Flight Procedures Cover Page	Task Action: FLIGHT CHECK	Task Type: STAR	Estimated Chart Date: 04/17/2025	APWS Task ID: F7F06827B39E4D589092BB42418423E8	APWS Project ID: AAE177B12CB1456D8640EC027DE44576
Procedure: STAR DADES TWO (RNAV) ST PETERSBURG-CLEARWATER FL KPIE		Enroute: YES	Specialist: Copeland, Guy		Agreement Number:
Airport ID: KPIE			Airport City: ST PETERSBURG-CLEARWATER		State: FL
Facility ID:	Facility Type:	Flight Inspection Remark Type: New FC Slot			
<div>Procedure Comments: CONTACT: ROBERT HAMILTON 405-954-4608 WAIVER: NO ALTITUDE RESTRICTION</div> <div><div>QUALITY 35 CHECKED</div><div>QUALITY 38 CHECKED</div></div>

FIPC DME/DME FORM						
PROCEDURE: STAR DADES TWO (RNAV) ST PETERSBURG-			AIRPORT NAME: ST PETE-CLEARWATER INTL		AIRPORT ID: KPIE	SPECIAL CONTROL NO: AG-12-189-24
FAC ID: DADES2		CITY: ST PETERSBURG-CLEARWATER			ST: FL	ORIG CHART DATE: 04/17/2025
DFL TYPE: PROC/D	THIRD PARTY: <input type="checkbox"/> YES	EST. TIME ON SITE: 0.5	REIMB. NUMBER:	PTS TASK ID: F7F06827B39E4D589092BB42418423E8		
PREFLIGHT NOTES						
REVIEWER:					DATE:	
COMMENTS:					CHECK ONE: <input type="checkbox"/> FLT CK REQ <input type="checkbox"/> NFCR <input type="checkbox"/> REJECT

DADES (RNAV)

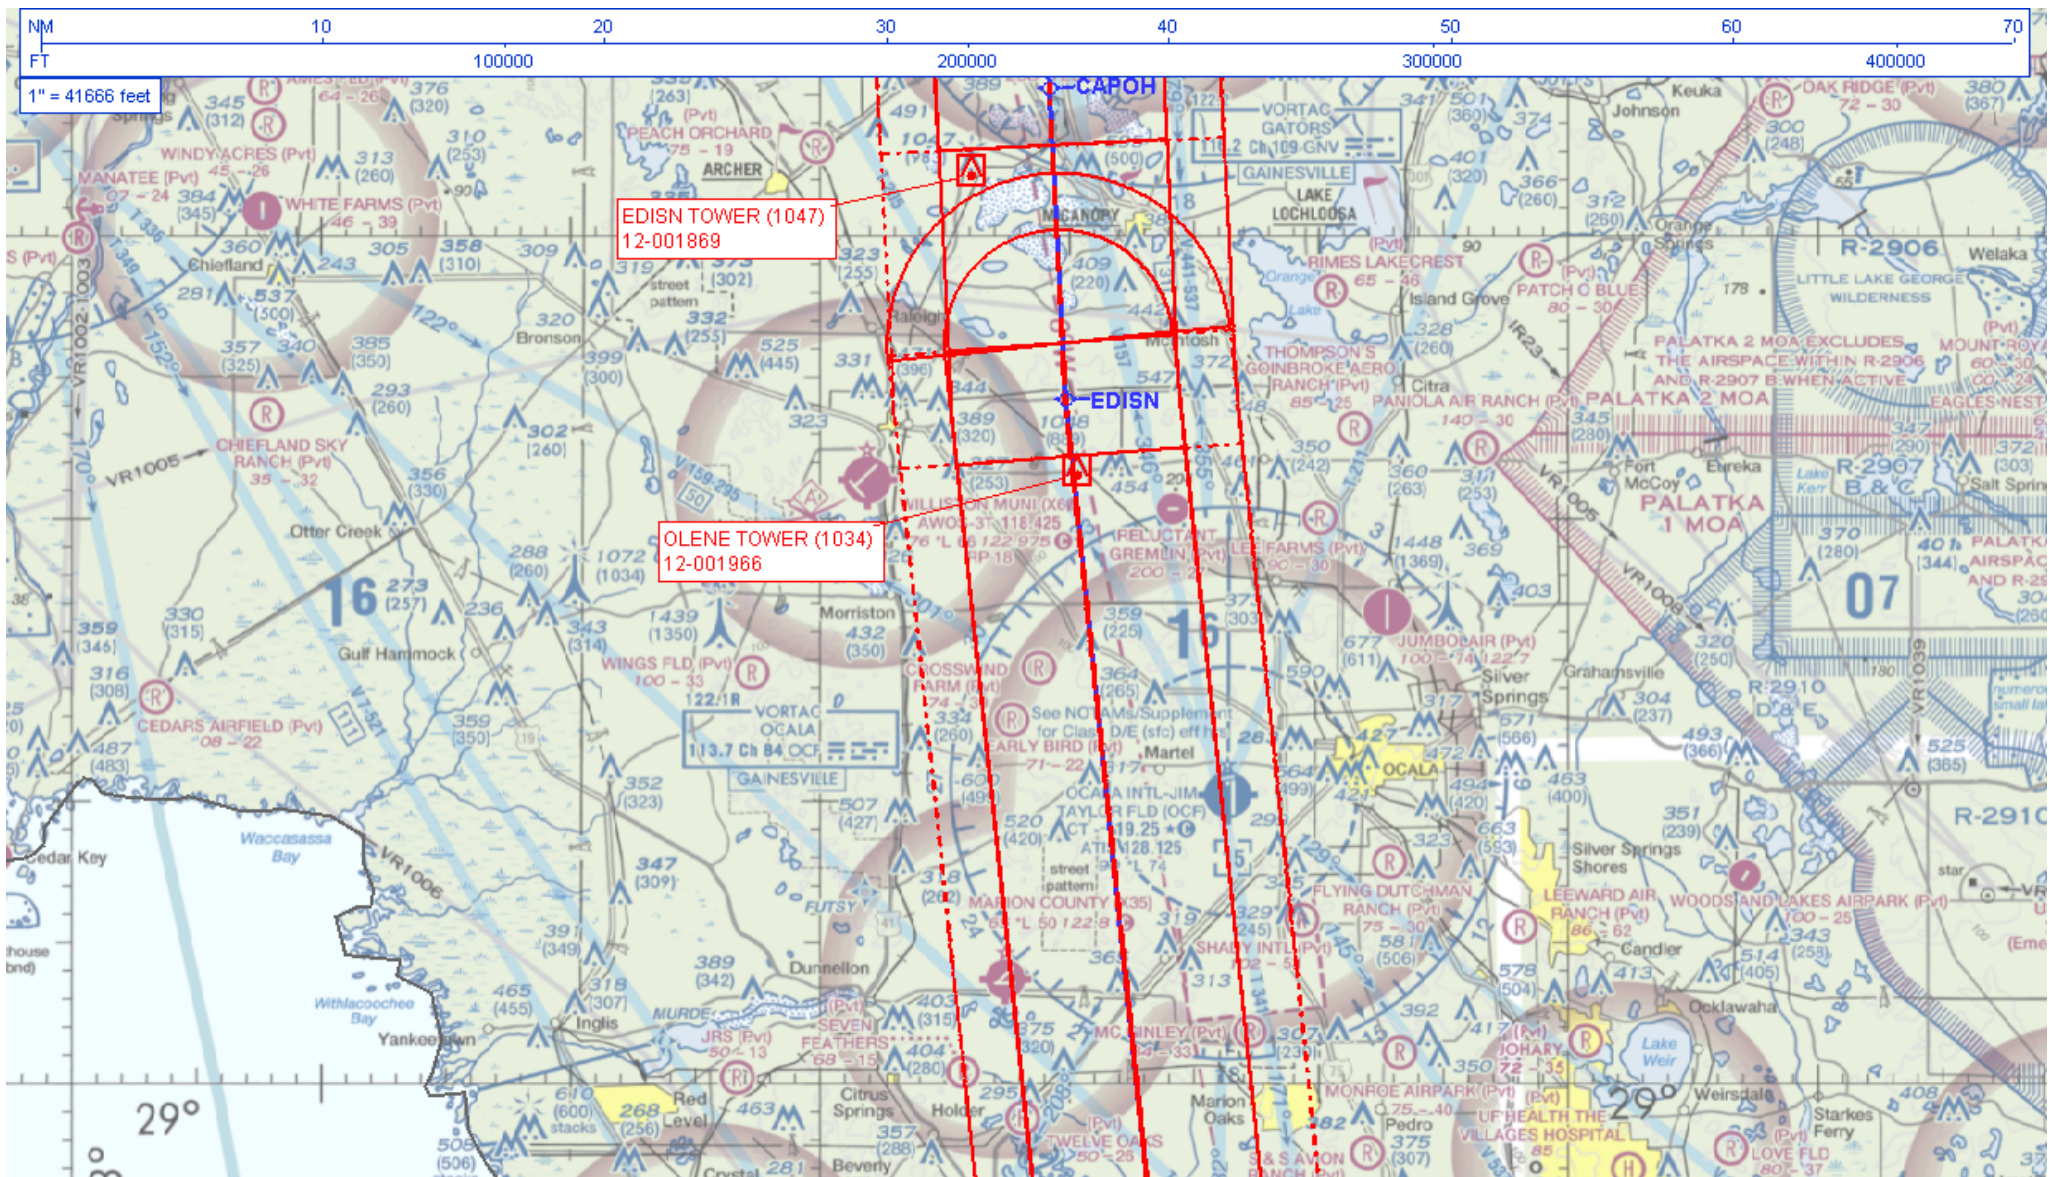
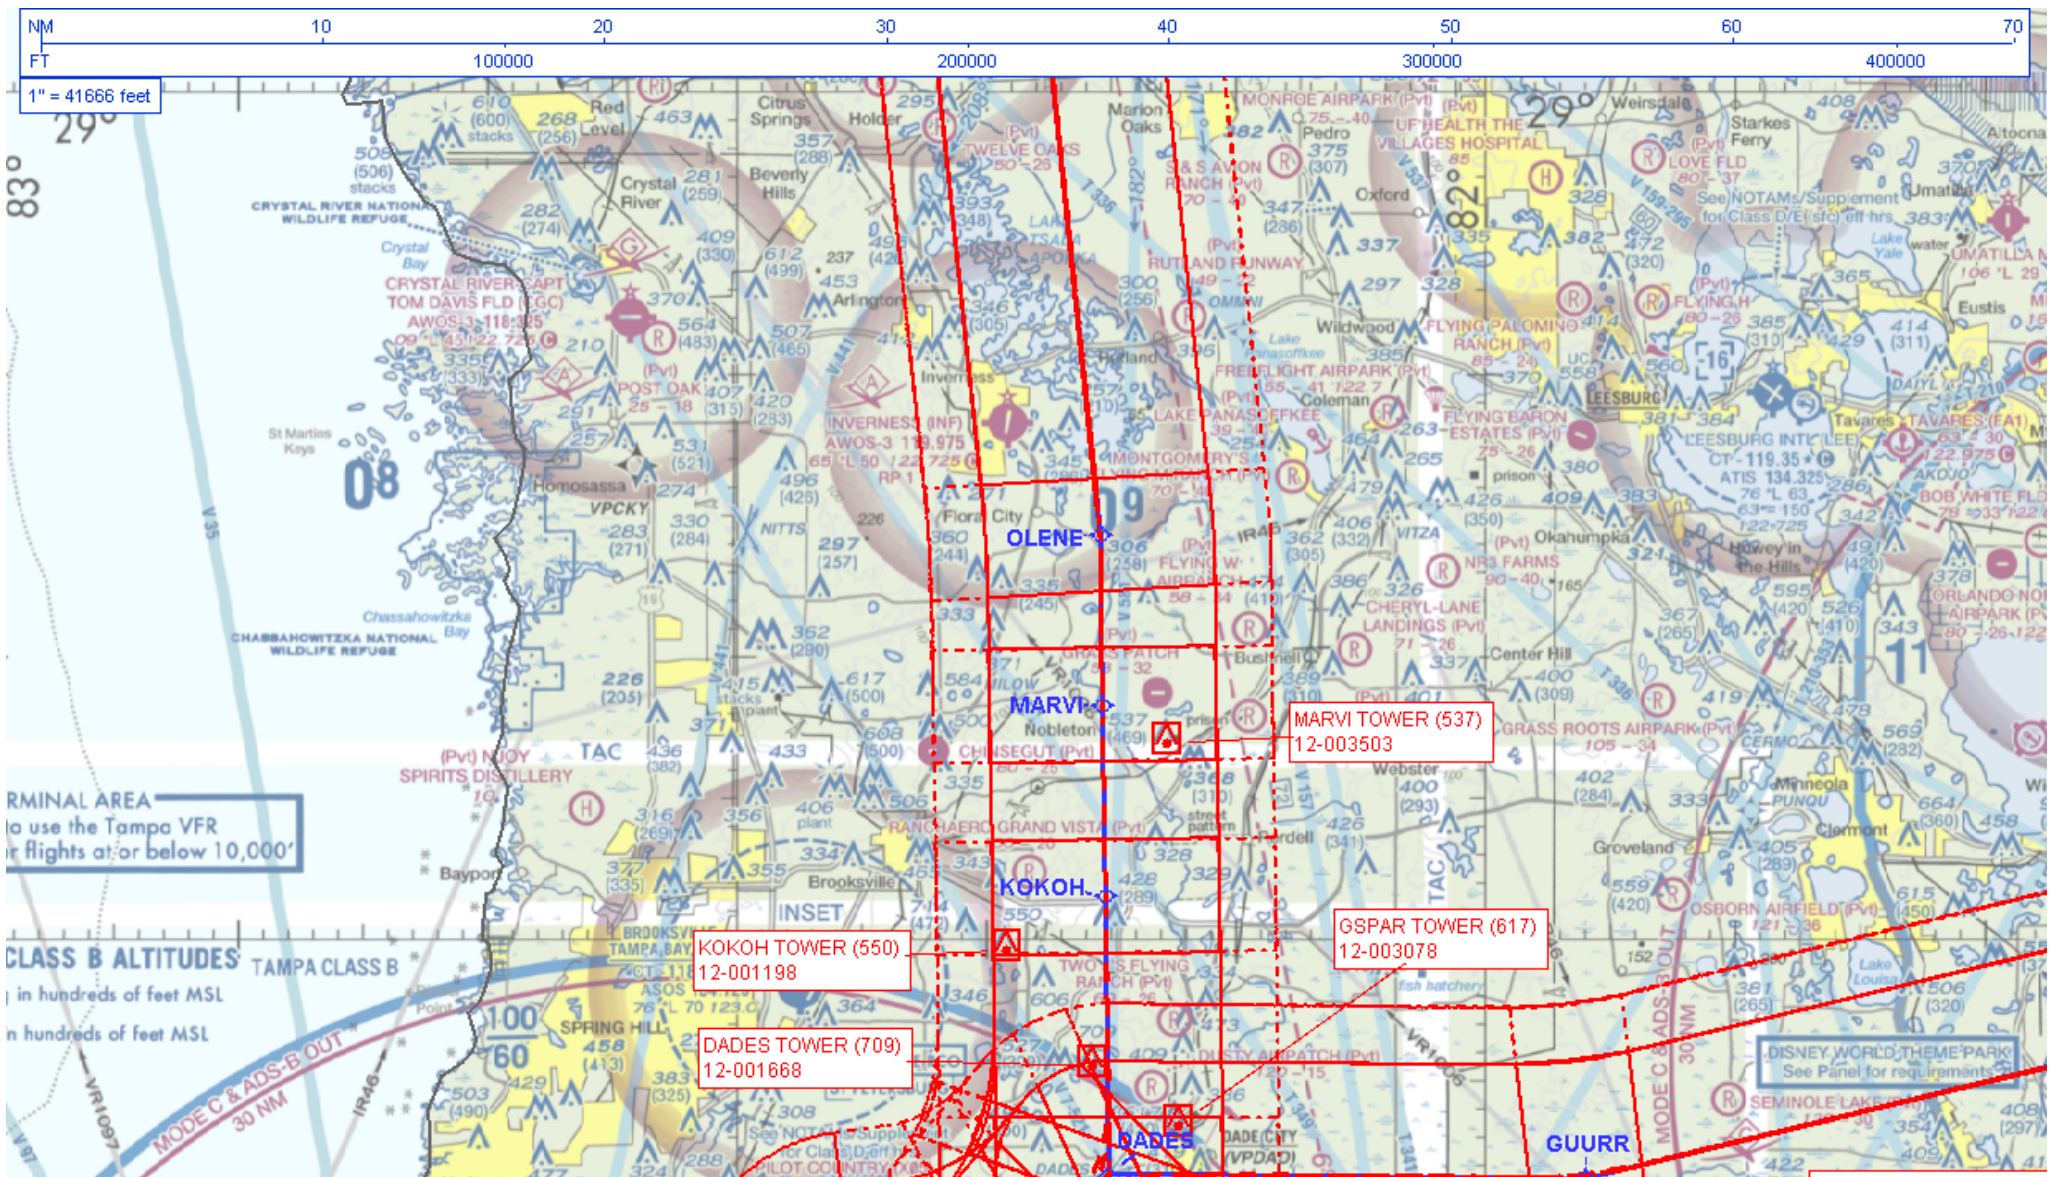
FLIGHT INSPECTOR SIGNATURE: kevin riese @ 01/17/2025 07:18			PRINTED NAME: RIESE, KEVIN JOHN			NOTAM INITIATED? <input type="checkbox"/> YES <input checked="" type="checkbox"/> NO
FLIGHT INSPECTOR REMARKS: ADDED KSPG, KCLW, KTPF TO AIRPORTS SERVED. ADDITIONAL CHARTING NOTES UPDATED. TABLE TOP REVIEW.						
DME/DME STATUS: <input type="checkbox"/> SAT <input type="checkbox"/> UNSAT	SPECIALIST SIGNATURE:				PRINTED NAME:	
SPECIALIST REMARKS:						
IN-FLIGHT OBSTACLE REPORT						
OBSTRUCTION ID #:	COORDINATES OR LOCATION:	GNSS ALTITUDE (MSL):	BAROMETRIC ALTITUDE (MSL):	HEIGHT ABOVE GROUND LEVEL:

LANDING KTPA RUNWAYS 10, 19L/R: From DADES on track 225° to LZARD, then on track 268° to cross JKBAL at 6000 and at 230K, then on track 277°.

LANDING KPIE/KMCF/KVDF: From DADES on track 186° to GSPAR, then on track 180°.
